BHP Pilbara Strategic Assessment

**Marillana Creek (Yandi)
Validation Notice**

Rev	Description Of Amendment	Organisation	Date Validation Notice Finalised	Date Validation Notice Effective From
Rev 0	Draft for public consultation	BHP Iron Ore Pty Ltd		
Rev 1	Updated in response to DCCEEW comments; final Validation Notice	BHP Iron Ore Pty Ltd	29 May 2026	29 June 2026

WAIO - PLANNING, TECHNICAL & ENVIRONMENT
 SCALE @ A4: 1:32,960 PREPARED: GEOMATICS FIGURE: 5-9
 DATE: 11/05/2026 REQUESTOR: ENV APPROVALS

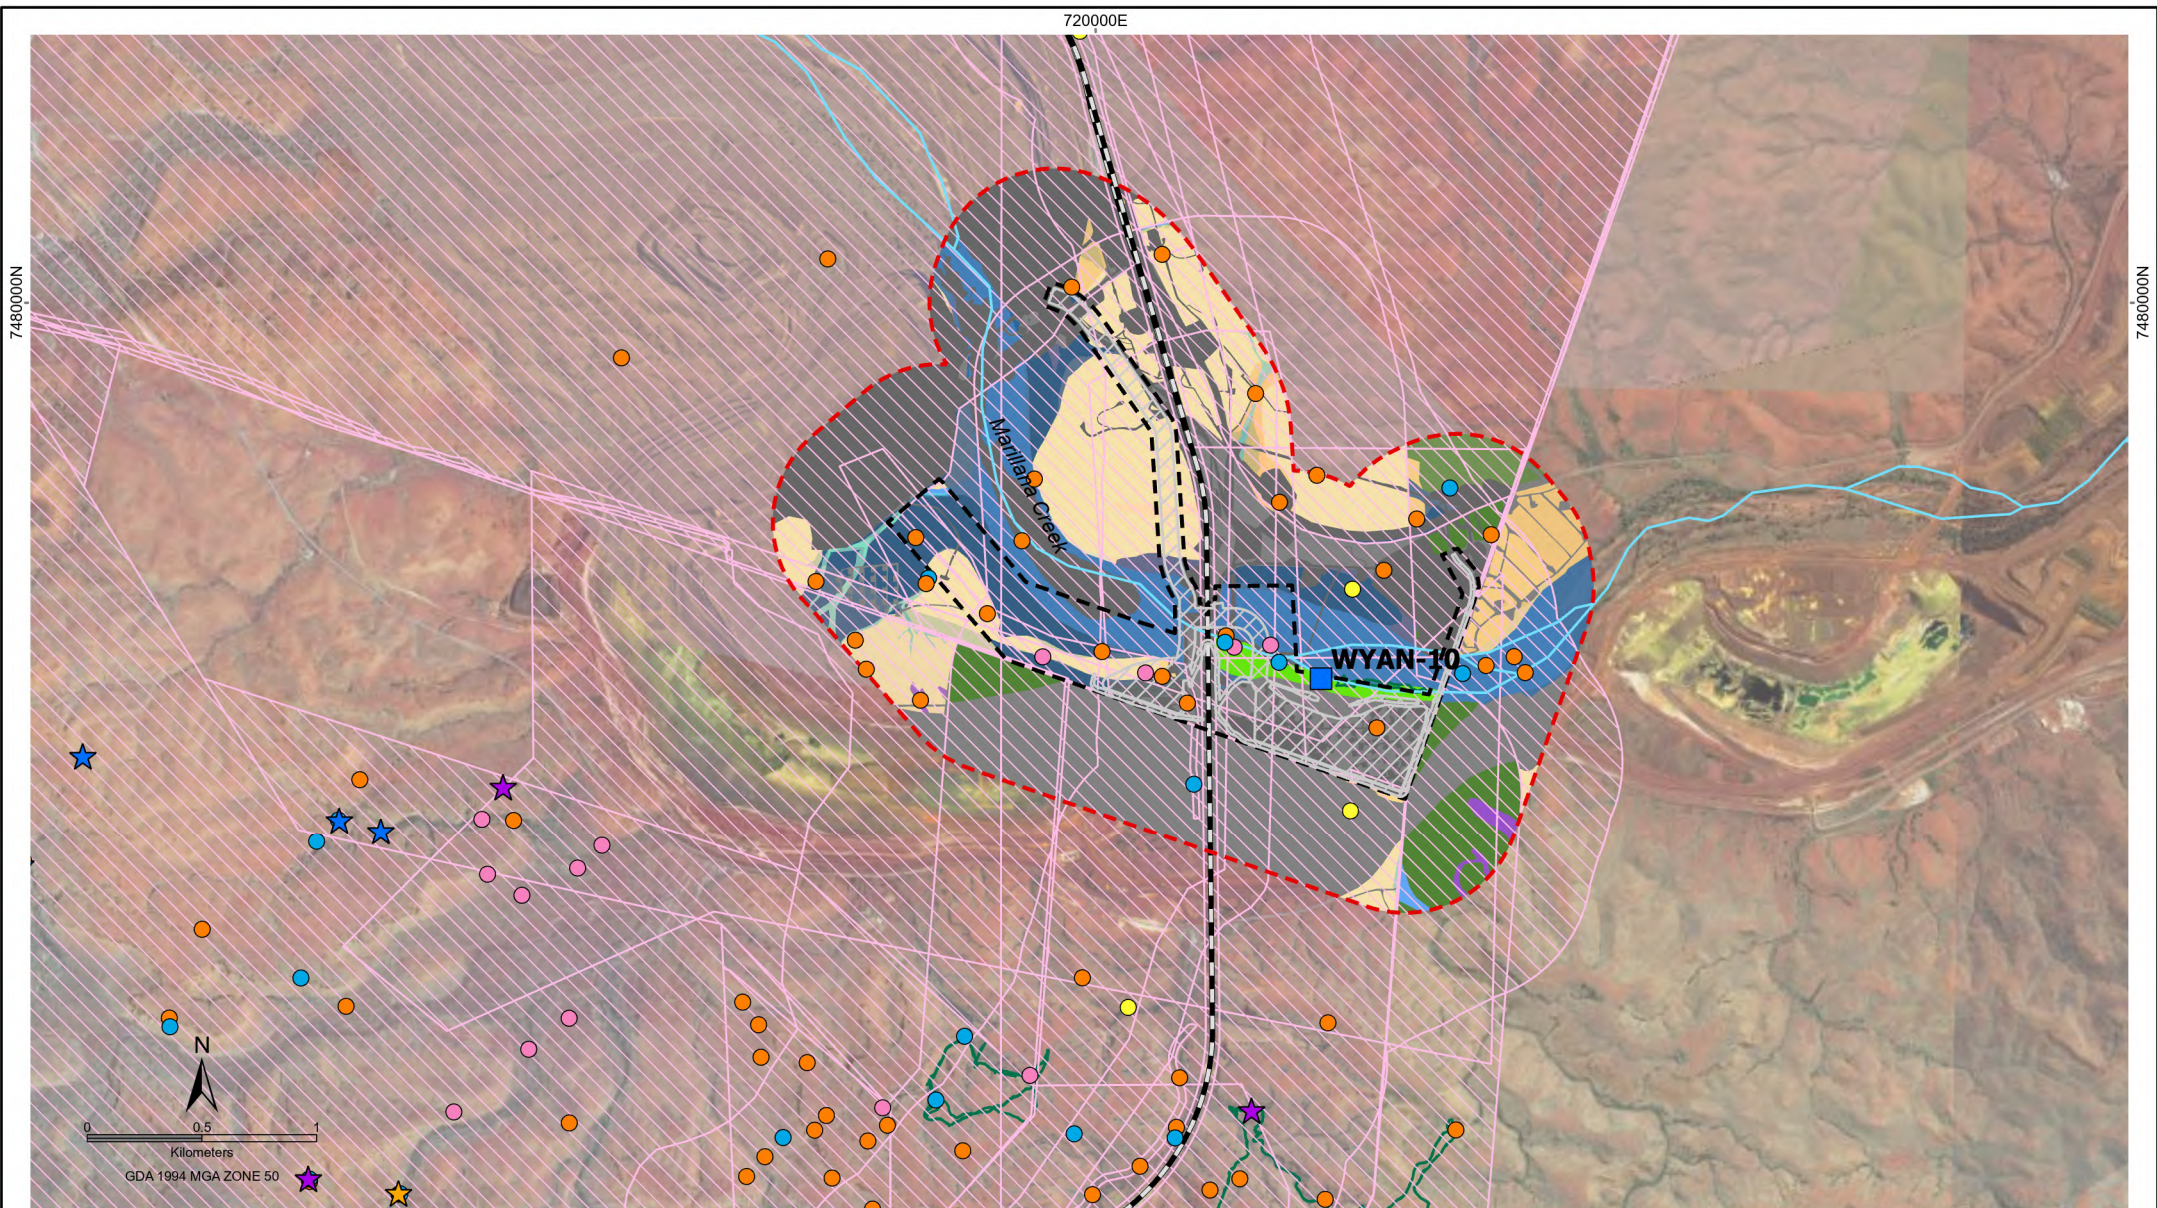
Comment Number	Issue	Comments	BHP Response
5.3 Northern Quoll			
No comments.			
5.4 Ghost Bat			
23	5.4.4-1 Ghost Bat Survey Coverage - Figure 5-9 (p. 58)	Confirm survey coverage east of the Activity Area (Figures 5-9). This is relevant to determine regional context and the nearby records/roosts.	<p>Areas east of the Activity Area, including within the 500m buffer, comprise of third-party mining tenements and operations. Biota (2026) conducted transect searches, habitat assessments and Bat Detector sampling sites in the 500m buffer, east and northeast of the Activity Area (refer to Figure 5-9). No signs of Ghost Bats were detected during the survey.</p> <p>The extent of current and historical survey coverage is considered adequate to determine regional context and nearby records/roosts. A population of Ghost Bat is present within the wider area. However, no Ghost Bats have been detected in the Activity Area, and no transient or dispersing individuals have been recorded within the 500m buffer, or within the BHP Yandi mining area during recent or historical surveys.</p> <p>No change to the final Validation Notice.</p>

WAIO - PLANNING, TECHNICAL & ENVIRONMENT
 SCALE @ A4: 1:88,000 PREPARED: GEOMATICS FIGURE: 5-10
 DATE: 13/05/2026 REQUESTOR: ENV APPROVALS

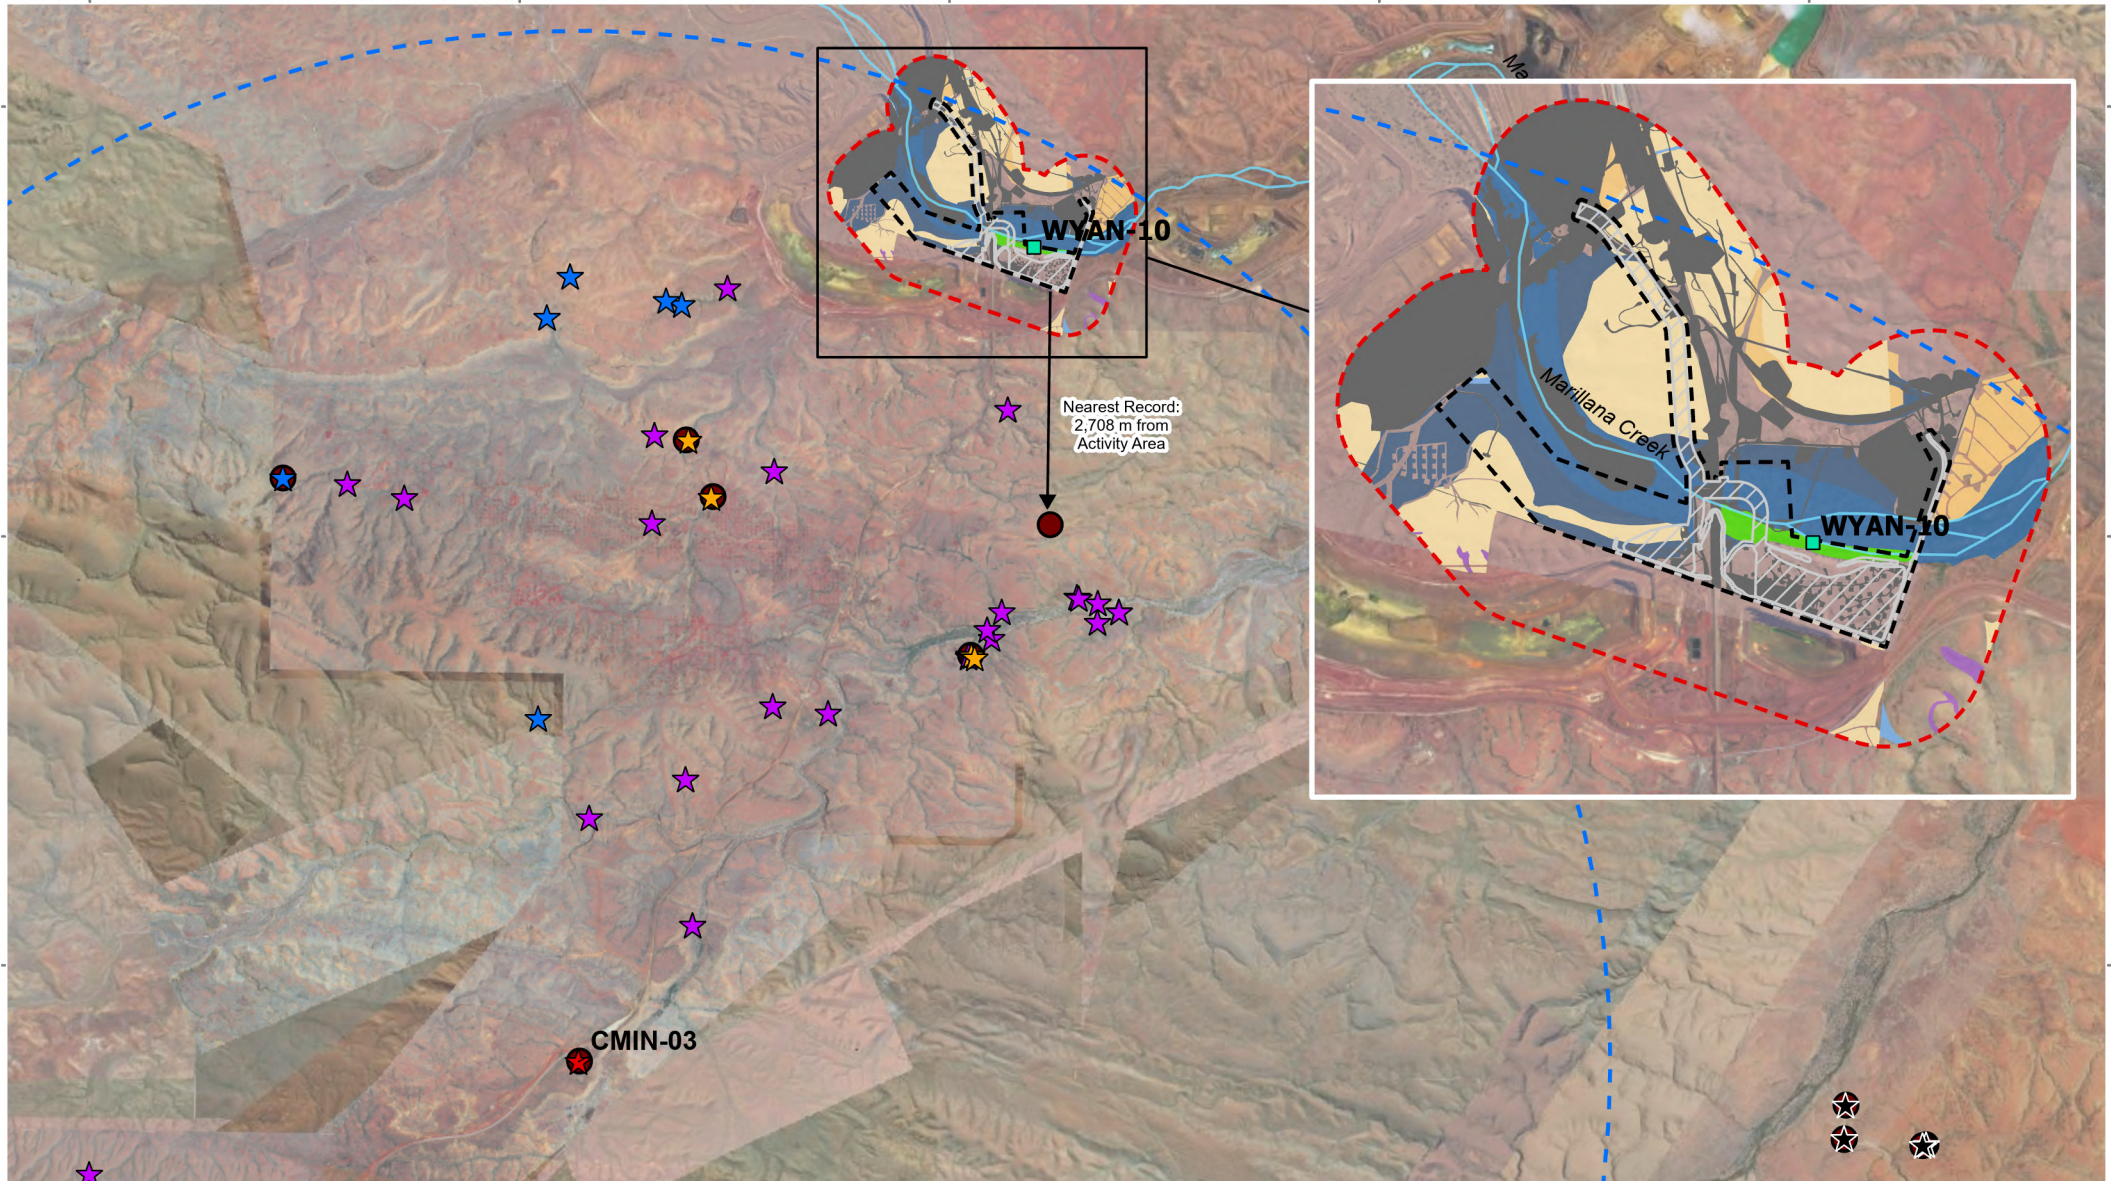
24	5.4.4-2 Ghost Bat Records - Figure 5-10 (p. 59)	Clarify apparent discrepancies between Figure 5-10 and Biologic (2025) survey results. The figure indicates that the nearest contemporary Ghost Bat record is 2.7 km from the Activity Area. However, the MAC to Yandi Corridor & Runaway Valley North survey (Biologic 2025) seems to indicate records of Ghost Bat activity (alive individual, scats, and secondary signs) closer to the site in 2024 (page 74). Please clarify if required.	The map shown in the final Validation Notice is accurate and no further update is required. BHP confirms that the nearest contemporary Ghost Bat record is 2.7 km from the Activity Area as recorded during the Biologic (2025) survey.
